egusphere-2024-2195

Responses to comments from Referee 1

Volumetric evolution of supraglacial lakes in southwestern  
Greenland using ICESat-2 and Sentinel-2

Figure R1: The coverage area of Sentinel-2 imagery from different dates during (a) the second and (b) third study periods.

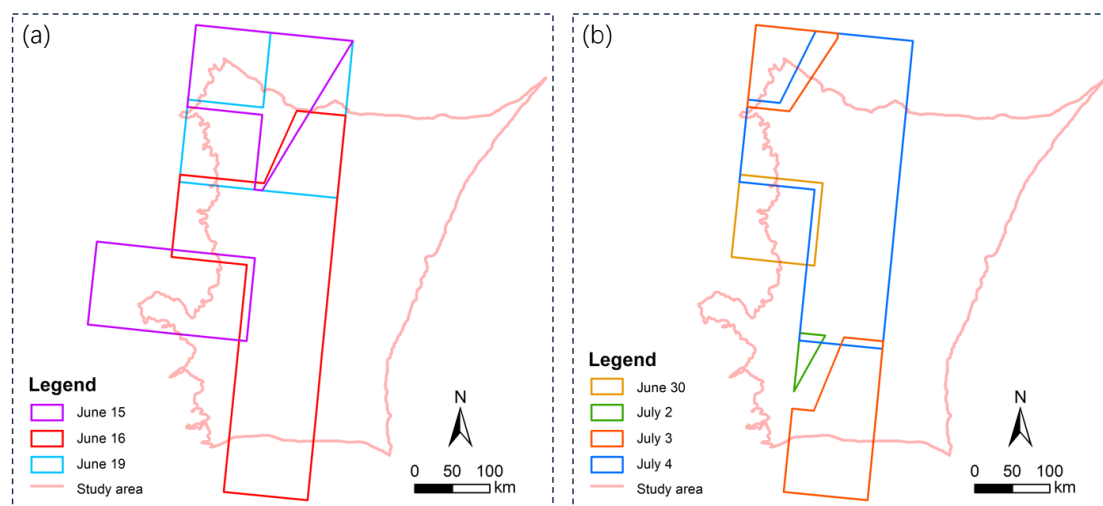
**14. Line 133-136, I am confused by the two sentences starting, “It should be noted that the” and “Therefore, we use”. Are you using multiple images from different days to make a composite image of one day which you then consider to be the ‘average’ day? You need to rephrase these sentences and make them easier to understand.**

Yes, we use multiple images from different days to achieve complete coverage of the study area, as no single day's imagery could cover the entire study area during the second and third study periods (i.e. 15th–20th June and 30th June–4th July). As shown in Figure R1, we use multiple images from the same period to achieve complete coverage of the study area. For overlapping regions from different dates, each individual image is processed separately, and the final result is obtained by averaging the processed outcomes.

We have rephrased these sentences in the revised manuscript.

(Line 138): “... *It should be noted that no single day's imagery could cover the entire study area during the second and third study periods (i.e. June 15–20 and June 30–July 4). Therefore, we use multiple images from different days to achieve complete coverage of the study area, denoted by June 17 and July 2 to represent these two periods in the following text. For overlapping regions from different dates, each individual image is processed separately, and the final result is obtained by averaging the processed outcomes. ...*”

Figure R2: The location of the image with a cloud coverage rate of 11.09%.

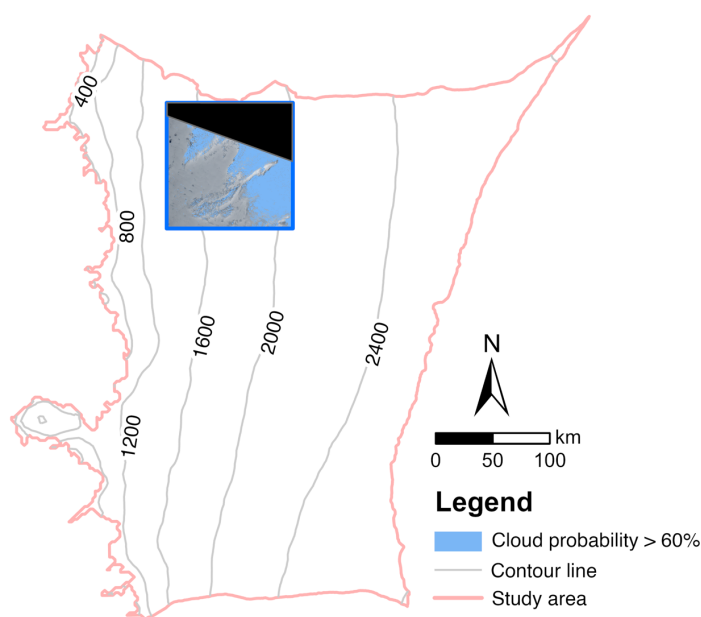
26. Line 164, you mention use of the QA60 band to remove cloud and shadow pixels, but the QA60 band is only available on Google Earth Engine for data pre-Feb 2022 and post-Feb 2024. What mask were you using here? I can't see how you could have used this dataset to mask cloud and shadow for your data which is from mid-2022. I am not convinced that cloud and shadow have been appropriately masked considering this.

We apologize for the oversight here. We did not remove cloud and shadow pixels due to the absence of the QA60 band. In our study, we use a total of 81 images, 53 of which have 0% cloud cover. Among the remaining 28 images, only one has a cloud coverage rate of 11.09%, while the others exhibit minimal cloud coverage, with an average of 1.62%. This image, acquired on August 28 and belonging to the last study period, is located as shown in Figure R2. According to the Sentinel-2 cloud possibility product downloaded from GEE ([https://developers.google.com/earth-engine/datasets/catalog/COPERNICUS\\_S2\\_CLOUD\\_PROBABILITY](https://developers.google.com/earth-engine/datasets/catalog/COPERNICUS_S2_CLOUD_PROBABILITY)), areas with a cloud possibility exceeding 60% (indicated in blue area in Figure R2) are primarily located on the right side of the image, at elevations of about 1800–2000 meters. This elevation range corresponds to the critical zone where supraglacial lakes typically form. Based on the development characteristics of supraglacial lakes, during this period, the lakes are retreating from higher to lower elevations as it marks the end of the melt season. Therefore, we conclude that the cloud coverage in this image does not significantly impact the results of our study.

We have deleted both the description of cloud and shadow removal and the box of “cloud and shadow removing” in Figure 2 in the revised manuscript.

*Figure 1. Study area. Contour lines calculated from ArcticDEM mosaic version 4.1 (Porter et al., 2023) are visible as grey lines at 400 m intervals. Yellow points indicate the locations of the lakes in the study area, as shown in Fig. 5 and Fig. 13.*

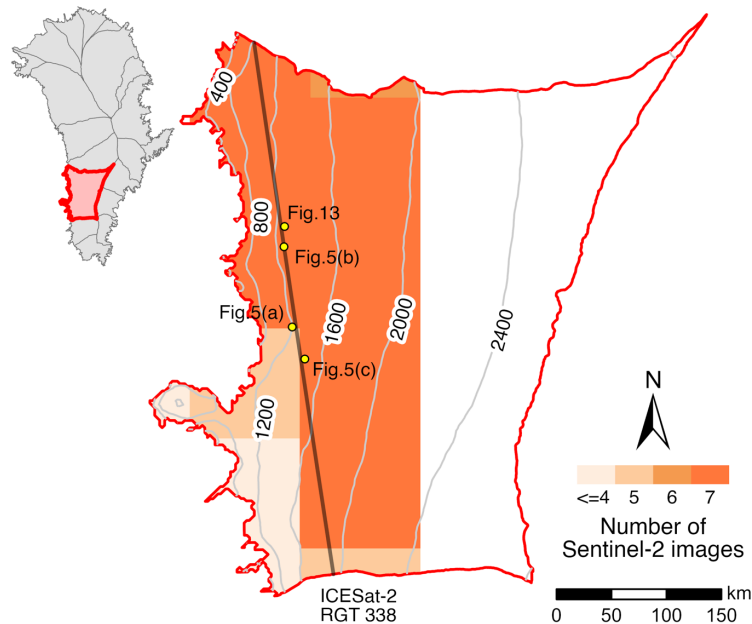
107. Please consider making the colour differences more obvious for the number of Sentinel-2 images. They are currently difficult to tell apart.
108. Scale bar, “KM” should be lowercase (“km”)
109. Caption, you mention ArcticDEM, is this the mosaic? If so, you need to detail which version and cite the appropriate documentation e.g. “Contour lines calculated from ArcticDEM mosaic version XX are visible as grey lines (CITATION).”

We have made the colour differences more distinct, changed “KM” to “km,” and added detailed information about ArcticDEM.

Figure 2. Framework of the proposed SGL depth inversion method.

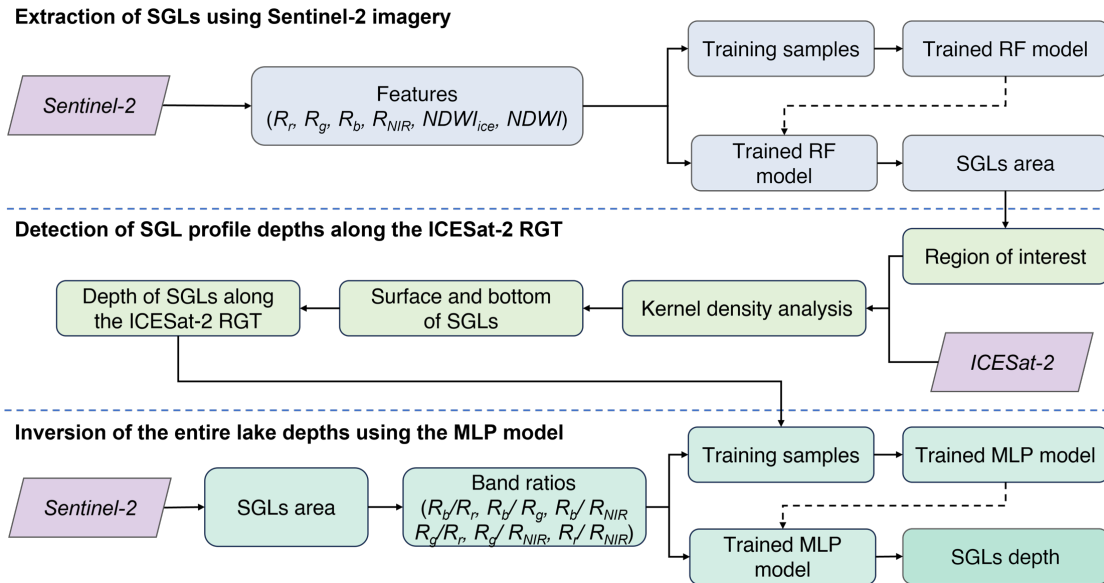
110. Box “Cloud and shadow removing”, change to “Cloud and shadow removal”
111. Box “SGLs Area”, change to “SGLs area” (both instances)
112. Box “Region of Interest”, change to “Region of interest”
113. Caption, change from “Framework of proposed SGLs’ depth inversion method” to “Framework of the proposed SGL depth inversion method”

We have removed box “Cloud and shadow removing” (see response #26 for

reference). The other boxes have revised as suggested.

*Figure 4. The comparison between the extracted extents and manually delineated contours for five different SGLs randomly selected from each study period, using the corresponding Sentinel-2 images as background for each period. Each row represents a different time period.*

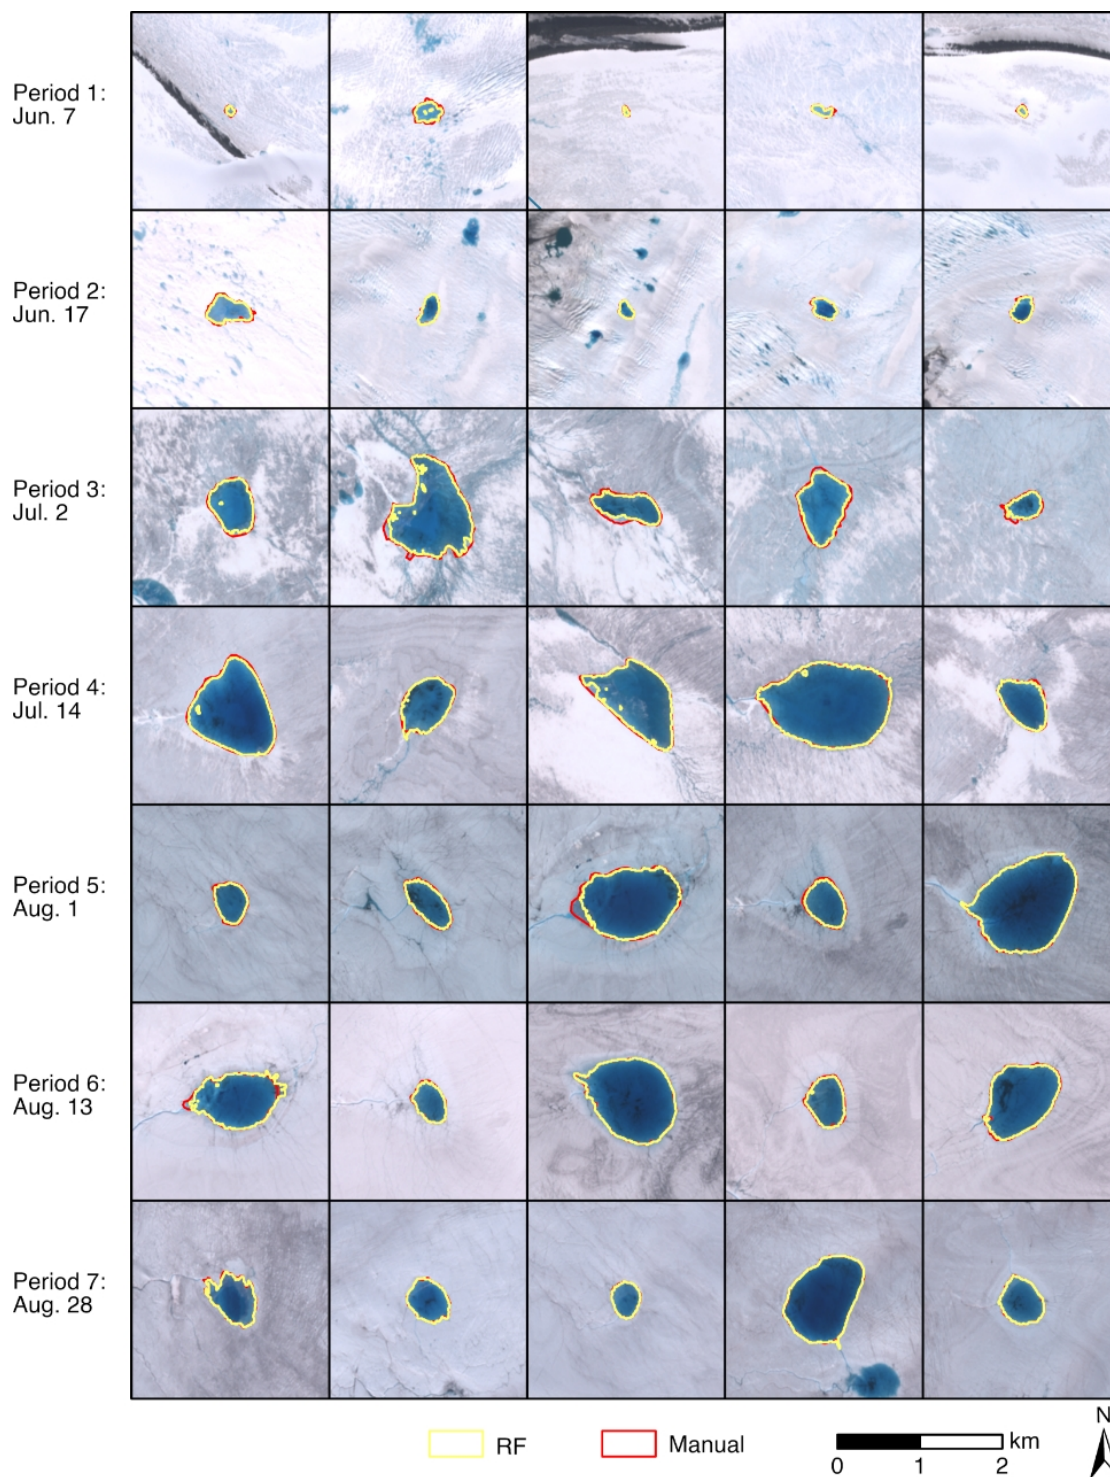
116. My assumption for this figure is that all of the lakes are different, but you need to be explicit about this in the figure caption at the very least.

117. I would suggest labelling the rows with details of each period e.g. Period 1: June 7 etc. This will make it easier to interpret and you won’t have to search the paper for details to understand the figure.

118. Scale bar, change “KM” to “km”.

119. Caption, remove “The first to seventh rows show” and add “Each row represents a different time period.” To the end of the caption.

We have revised the caption and revised Figure 4 according to suggestion.

Figure 5. Three examples of lake surface and bottom detection results based on ICESat-2 ATL03 data. The locations of lakes (a), (b), and (c) are shown in Fig. 1.

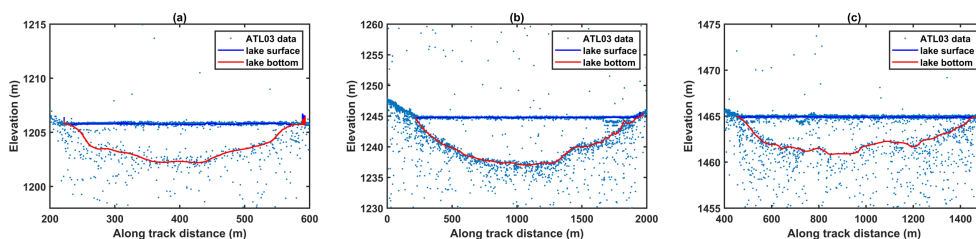
120. Are these results indicative, or are they your only results? What do panels (a), (b) and (c) represent? This needs to be explained in your figure caption.

121. Axes labels, each label is missing a space between the label and the unit e.g. “Elevation(m)” instead of “Elevation (m)”, please alter these.

These three lakes are indicative, and we have revised the caption. We also added a space between the label and the unit.

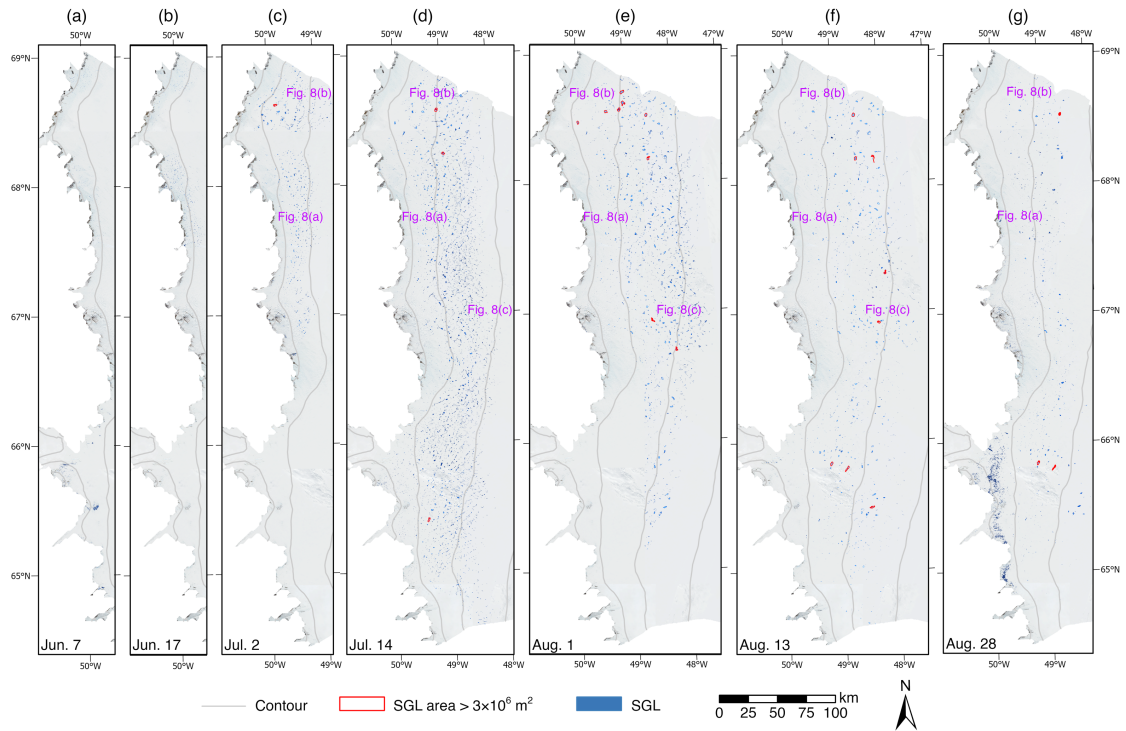
**128. Fig. 8 superimposed boxes, please ensure that these are plotted last as a few are slightly obscured by the SGLs which is making the plot look messy.**

**129. Fig. 8 superimposed box labels, each of these should be “Fig. 8(X)” not “Fig.8(X)”, they are all missing a space after the period.**

**130. Lat/Lon dashing, either remove this or make it darker. Right now, it is too faded to be of any use to your reader.**

**132. Change “SGLs Area” to “SGL area”**

**133. Change “SGLs” to “SGL” (after blue box)**

**134. Scale bar, change length to 100 km with markers/intervals at 0, 25, 50, 75 and 100. This will typically be of more use to your reader.**

**135. Scale bar, change “KM” to “km”**

**136. Caption, change “SGLs’ area” to “SGL area”. Where are the contour lines from? I am assuming that they are from ArcticDEM like Fig. 1, but the reader needs to know if it’s the mosaic, which version, and have the citation. Please also include the contour distance in the caption too (400 m) e.g. “Contour lines from ArcticDEM mosaic version X are also shown in grey at 400 m intervals (CITATION).”**

We have changed the order of the layers to ensure that the superimposed boxes are at the top layer. We have added a space between “Fig.” and “8”, changed legend and scale bar, removed the Lat/Lon grid, and revised the caption.

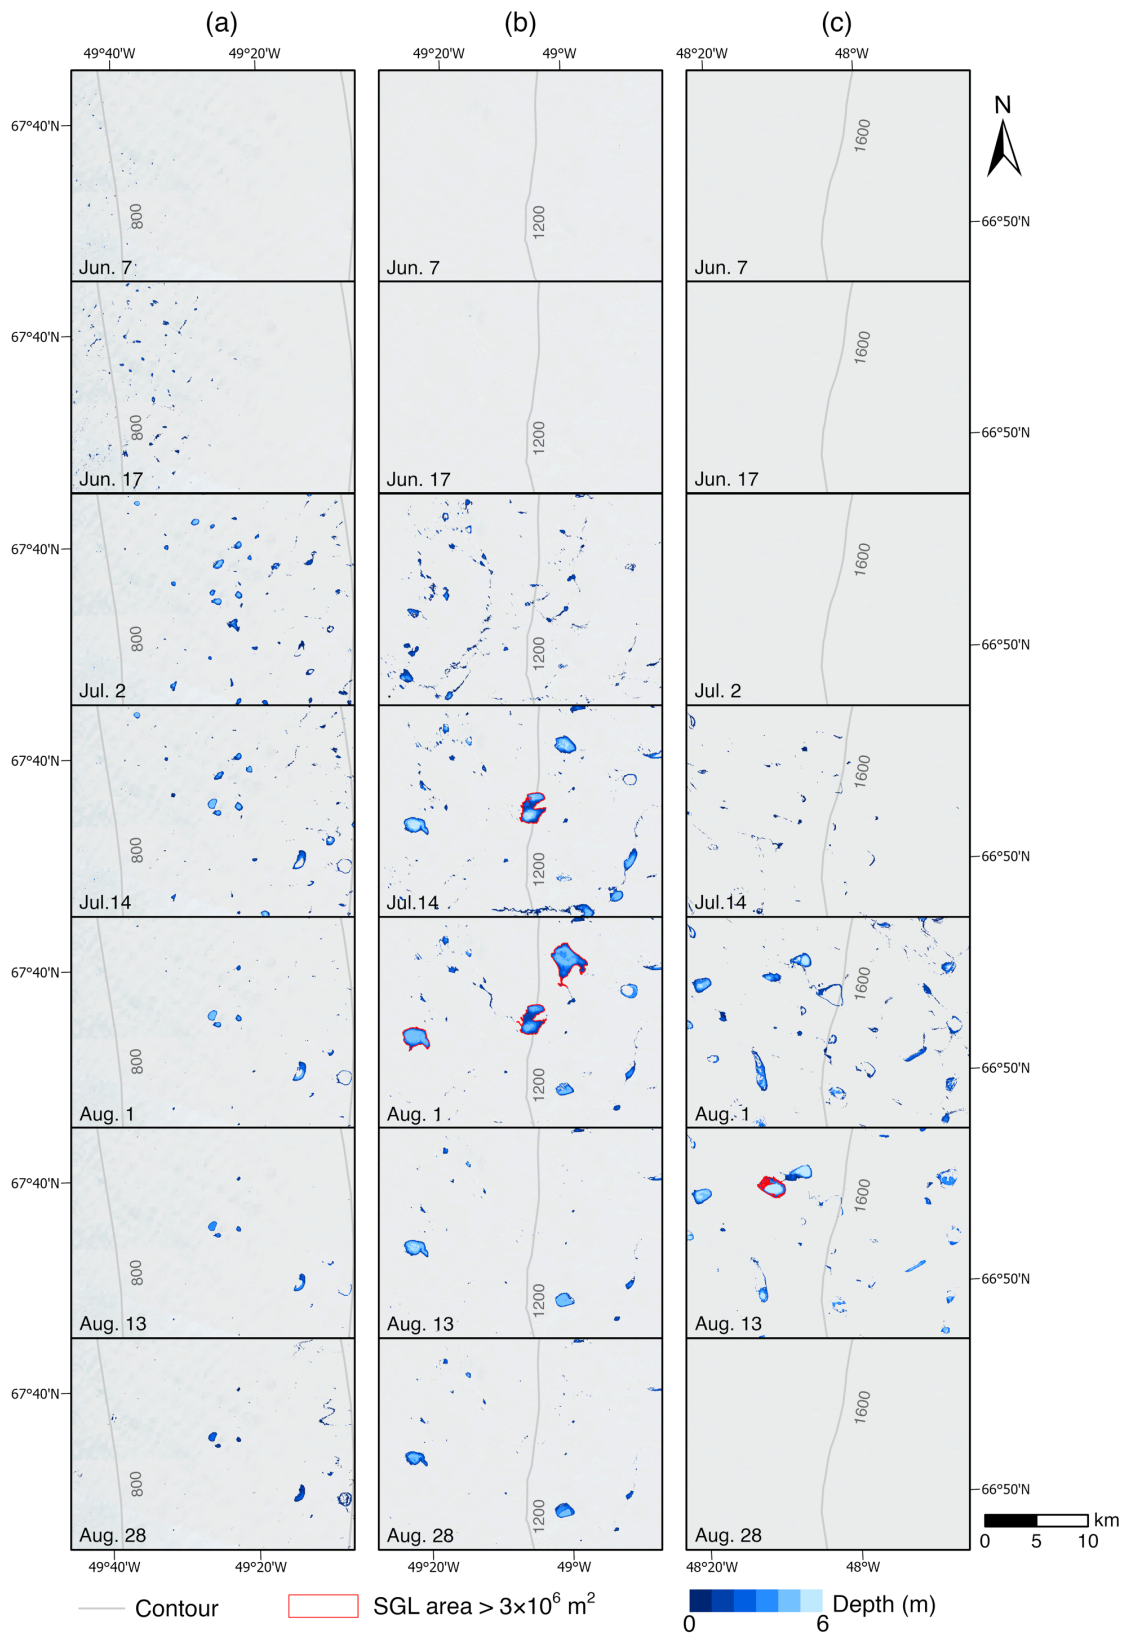
**137. Labelling (dates), ensure the label spacing is the same for the dates in the corners of your plots as some of the labels are currently going over the bounding boxes (e.g. the ‘g’ of Aug. 28)**

**138. Change either the colouring of the depth colour bar to not include red, or change the colour of the SGL area > 3 x 10<sup>6</sup> m<sup>2</sup> box as this is currently a bit confusing. I would suggest changing the colour bar to something more colourblind friendly instead of red as you won’t have to change previous figures then like you would have to if you changed the red outline colour for SGL area > 3 x 10<sup>6</sup> m<sup>2</sup>.**

**139. I would also suggest making the colour bar discrete instead of continuous. You won’t lose much definition given that the plots are so small anyway, and it will aid your reader in their interpretation.**

**140. Change “KM” to “km”.**

**141. Change “SGLs’ Area” to “SGL area”.**

**142. Caption, change “on the evolution” to “of the evolution”. Where are your contour lines from? Need source, version, citation please.**

We have adjusted label positions, modified the depth bar to make it discrete at 1m intervals, changed the legend, and revised the caption.
